I-5 Boone Bridge and Seismic Improvement Project: Evaluation of Travel Demand and Land Use Impacts

I-5 Boone Bridge and Seismic Improvement Project: Additional Analysis Requests and Agency Response

Figure 1: I-5 Facility Plan Recommended Improvements

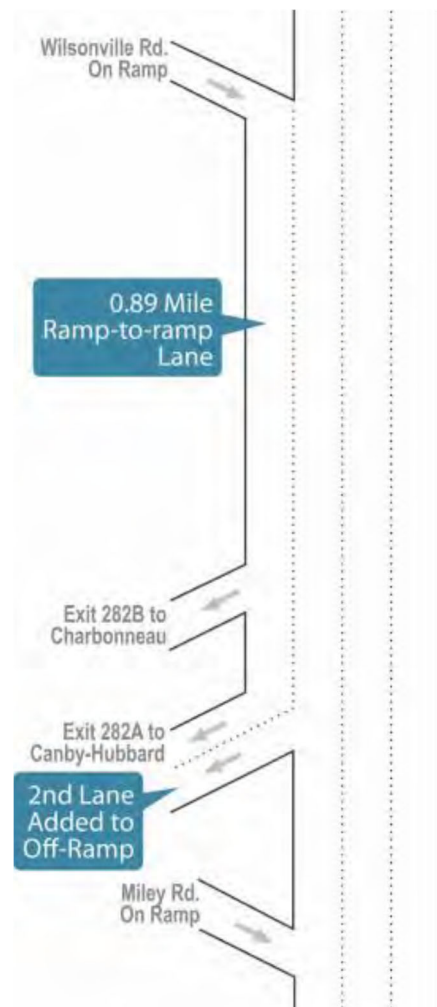
Analysis request: Consider managed-lane strategies that improve the use of each lane, such as a barrier-separated auxiliary lane from Wilsonville Road entrance ramp to the Charbonneau exit. This would be a separate entrance to Boone Bridge only from Wilsonville Road and other on-ramp lanes would be used for I-5 southbound traffic. This lane would be assessed for improving local connectivity for the Wilsonville and Charbonneau communities and improving related transit operations. Consider making the barrier separated auxiliary lane to create a bike/pedestrian and emergency vehicle path.

Agency response: Traffic analysis conducted in support of the I-5 Wilsonville Facility Plan indicates that local trips on I-5 southbound between the Wilsonville Road entrance and Charbonneau/Miley Road exit account for roughly 5% of vehicles using the Boone Bridge during the PM peak. ODOT anticipates the investment associated with building a new structure that would serve southbound trips to be significant. A barrier-separated auxiliary lane would likely require additional widening and investment without providing additional benefit towards local connectivity beyond those provided by a non-barrier-separated auxiliary lane.
